Zoning Board of Appeals Meeting of April 8, 2026**Application No. ZBA 2026-007**

Applicant:	Wayne Lensing
Location:	13750 Metric Road (04-16-326-003)
Requested Action:	Design Review for the construction of an 11,952 square foot building
Existing Use:	Self-Storage, Museum, and Retail Sales
Proposed Use:	Self-Storage, Museum, and Retail Sales
Existing Zoning:	IG (General Industrial)
Adjacent Zoning:	North: UT (Urban Transitional) East: IL (Light Industrial) South: IL (Light Industrial Winnebago County) West: Access ramps to and from Route 251

Description: The applicant is requesting Design Review and approval for the construction of an 11,952-square-foot building to house a fire truck exhibit, along with associated surface parking for visitors, located at 13750 Metric Road. The proposed development would expand the Historic Auto Attraction Museum.

Building Elevations

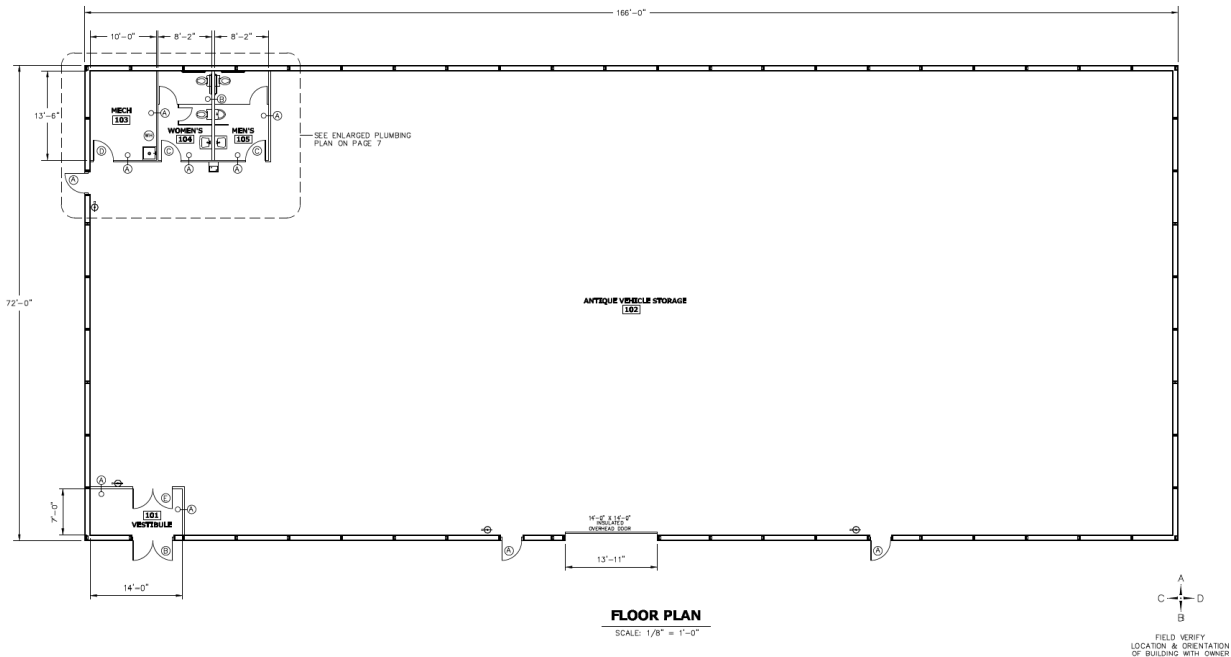
Building Design: The proposed elevations indicate that the exterior will feature Max-Rib II steel panel siding in a light stone color, accented by a 3-foot steel wainscot trim in Tudor Brown, and will be constructed on a concrete slab. The color palette is designed to complement and align

with the existing museum's aesthetic. The building's location meets the IG zoning setback requirements and complies with height regulations, as the proposed height of 26.5 feet is well below the maximum allowed.

Proposed Site Plan

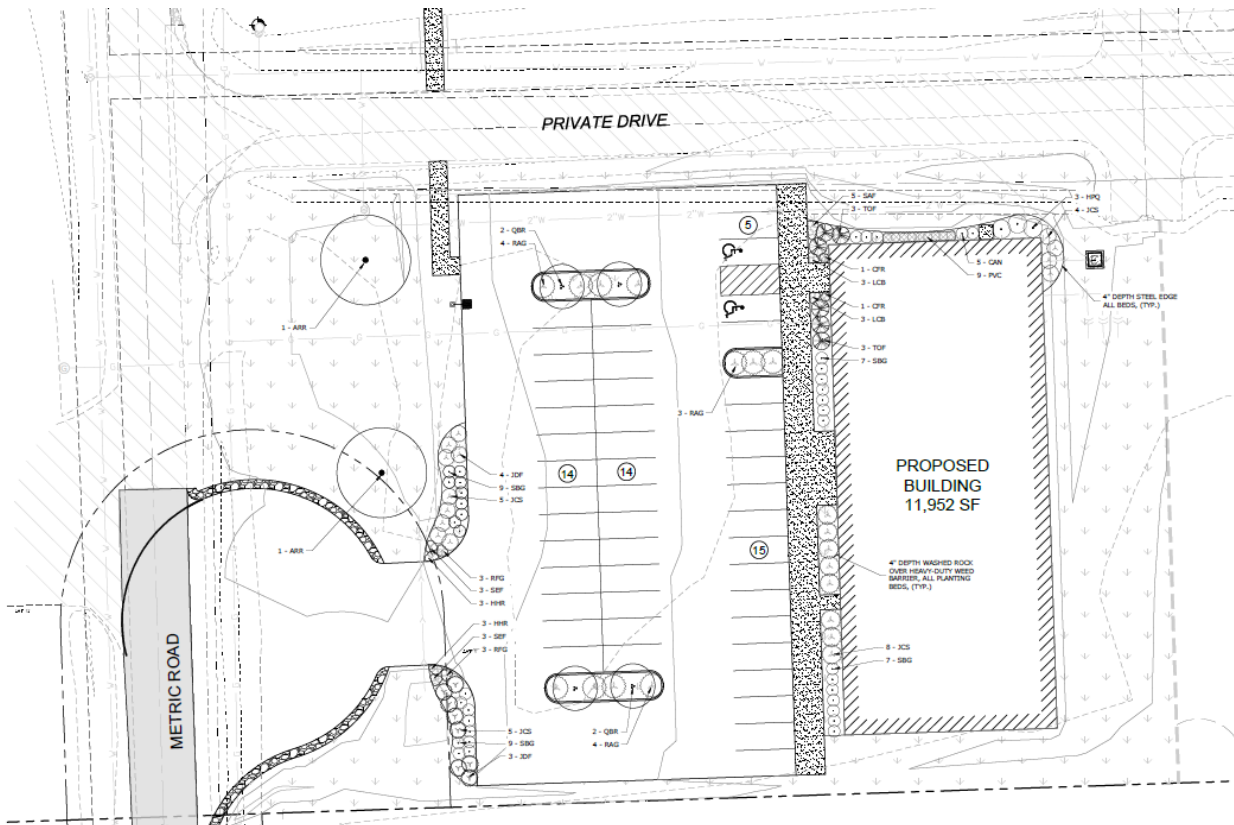
Parking Lot Design and Layout: Access to the site will be provided from Metric Road and a new dedicated cul-de-sac, in compliance with the annexation agreement. Wheel guards are required for parking spaces adjacent to sidewalks, pedestrian circulation areas, or landscape areas so that no part of a parked vehicle will encroach but are not required for interior stalls. The applicant will need to include wheel stops along the parking stalls that front of the building, adjacent to the sidewalk that spans the front façade.

The parking lot surface is proposed to be asphalt, and the stalls and drive aisles meet code requirements. Pavement surface striping should define each parking space, and shall be a minimum of four inches in width from the length of each space. Striping for each parking space shall be painted yellow or white. Thermoplastic pavement markings are an acceptable

alternative. A 6-foot-wide concrete pedestrian access has been added from the existing Museum parking lot to the new proposed parking lot to improve on-site circulation.

Section 15-619 of the Zoning Code regulates off-street parking requirements. Museum land uses require one off-street parking stall per 250 square feet of building. Based on the size of the proposed building, 48 parking stalls are required, and the site plan provides all 48, including two ADA-compliant spaces.

1. The applicant shall install the materials that have been reviewed and approved by the Zoning Board of Appeals.
2. The applicant shall include wheel stops on the proposed site plans along the parking along the front of the building adjacent to the sidewalk that spans the front façade.
3. The parking lot shall be striped in full compliance with all applicable code requirements.
4. The applicant shall obtain all necessary development permits.
5. The applicant shall address all Village Engineer comments regarding stormwater, utilities, and detailed site grading before issuance of an occupancy permit.
